Firmware PowerZone® Connect - 2026.32.0

PowerZone® Connect - 2026.18.1

Firmware 1.8.0

- **Two additional priority input levels per zone.**

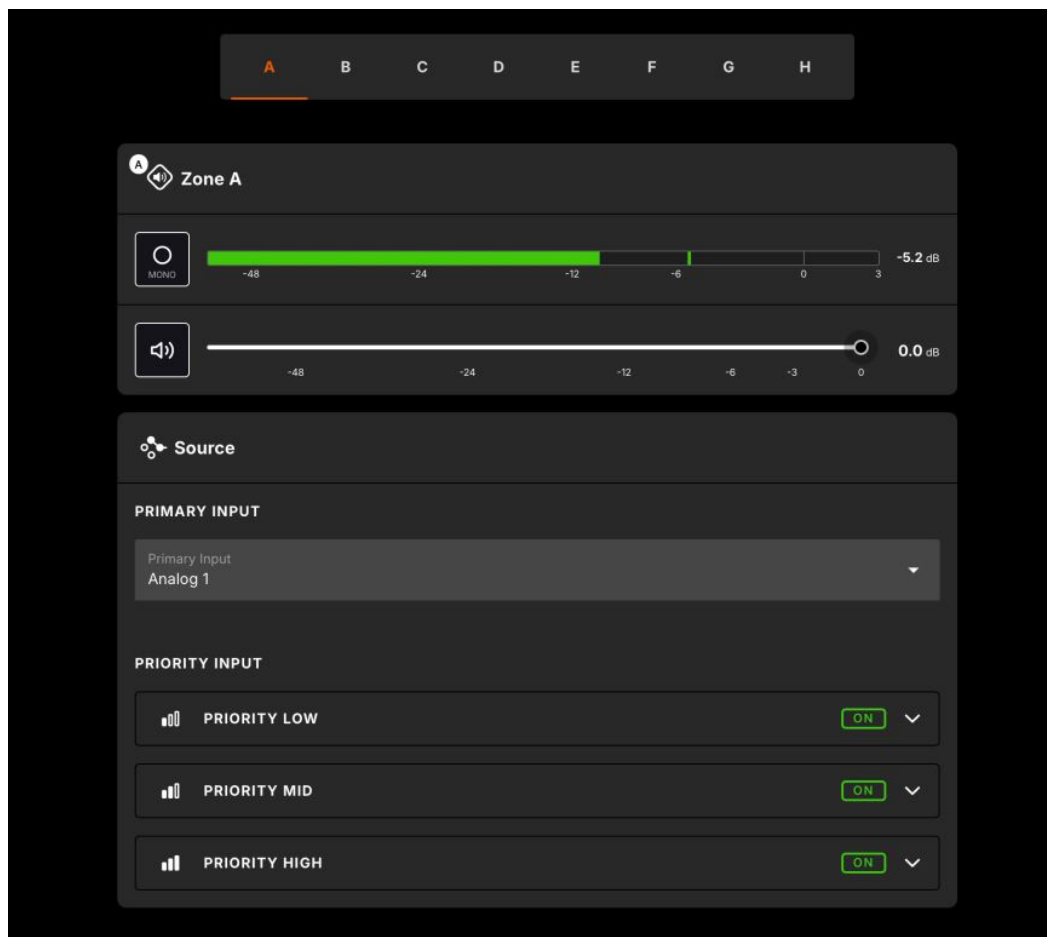
- This update adds two extra priority input levels per zone, expanding system flexibility. The new priorities include:
 - Threshold control
 - Zone volume override
 - Hold time functionality
- Example setup – retail environment:
 - Primary input: Background music
 - Priority Low (overrides primary input): Commercials
 - Priority Mid (overrides primary and low input): Microphone announcements
 - Priority High (overrides all): Voice alarms

- **Dark mode is now the default appearance setting.**

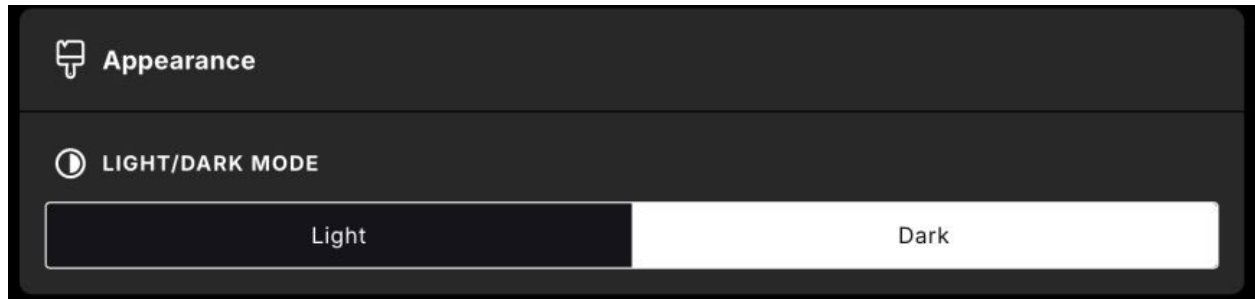
- A new “Appearance” tab under Settings lets users switch between Light and Dark mode. This setting applies only to the selected amplifier and does not affect the PowerZone™ Control Center interface

Features

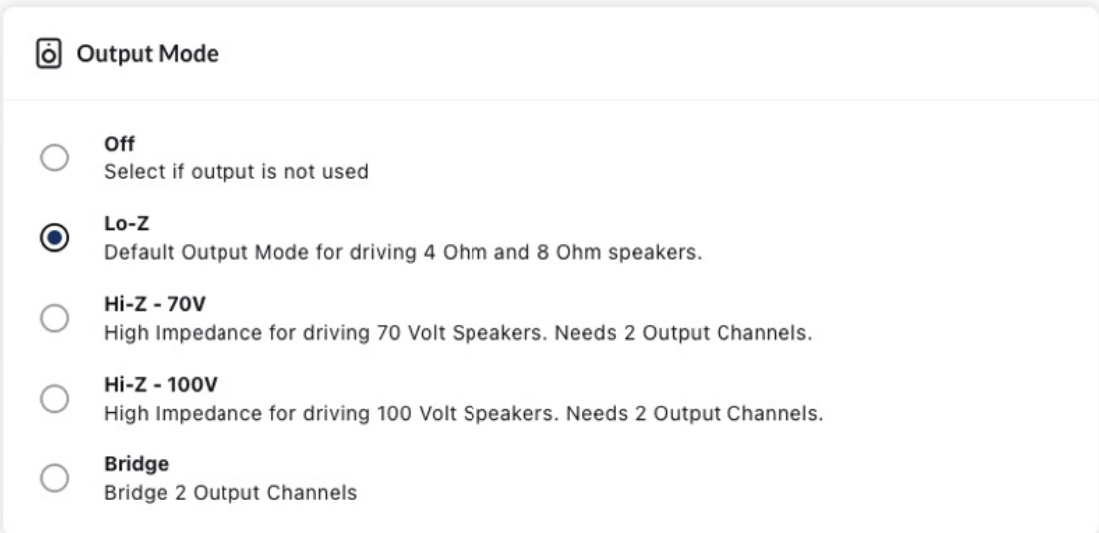
- Enabling BTL mode / Bridge mode on 1U units.
 - This has always been enabled for 2U units, but it is now enabled on 1U units as well, so the installer can bridge two output channels together.

Access restrictions:

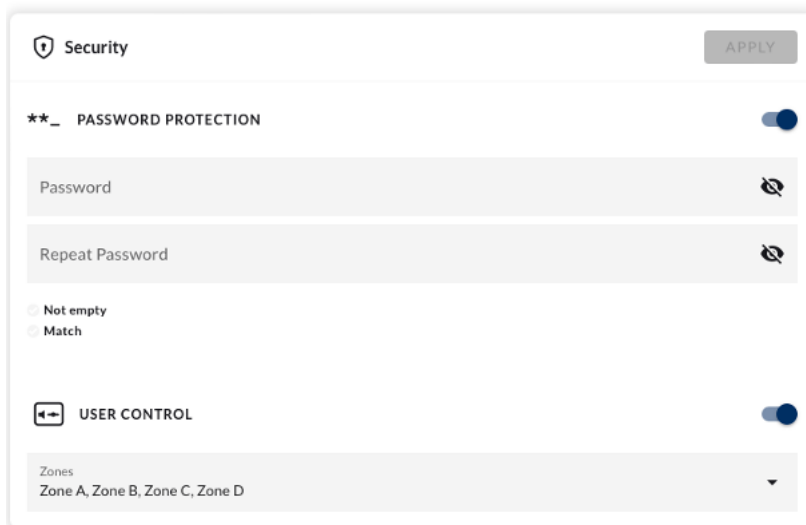
- End users are limited to the page “User Control”.
 - Installers can log in for advanced settings and configurations. This is setup through the tab “Security”, where they first setup a PIN which ensures that it is only an installer that can access the configuration of the amplifier, while the page “User Control” is accessible to end users.

Area 1 – Button arrangement (EQ)

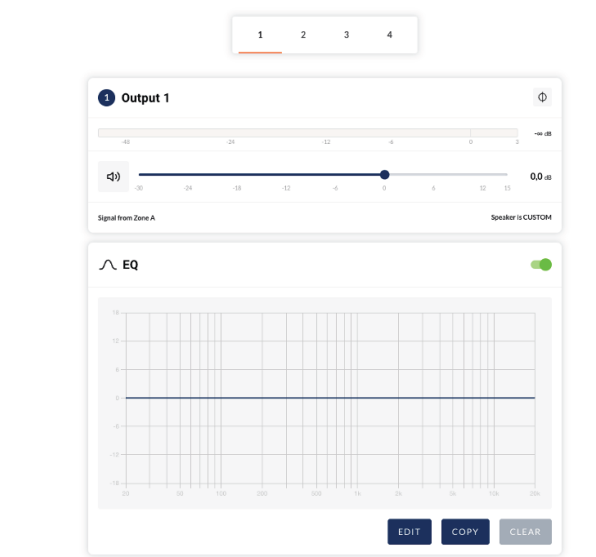
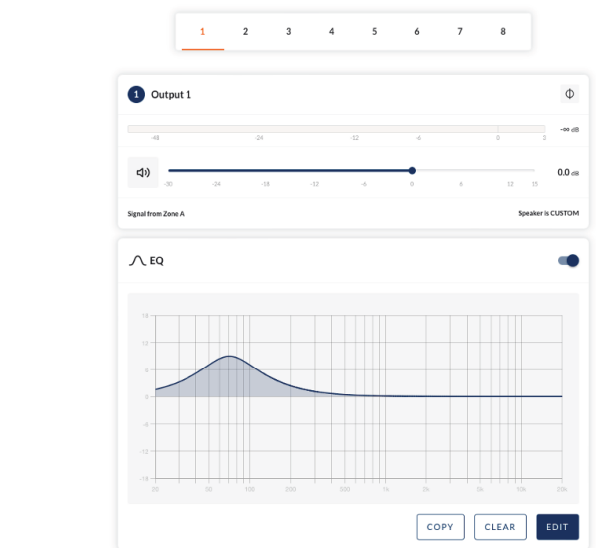
Primary buttons are placed towards the right, while the secondary buttons from left to right.

Area 4 – Secondary buttons e.g., “Reset” is outlined

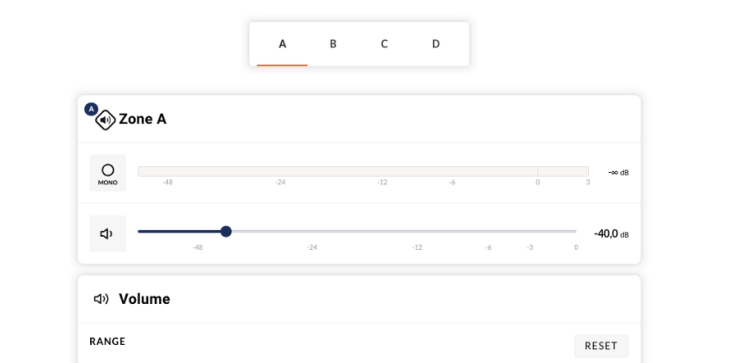
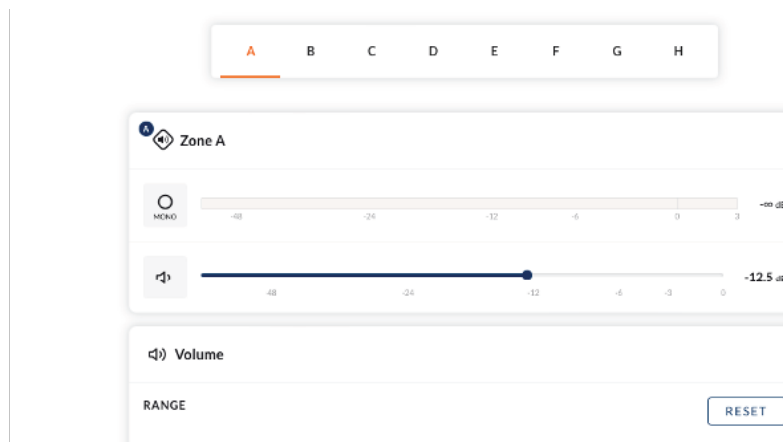
This goes throughout the entire GUI, so all secondary buttons are marked with an outer line.
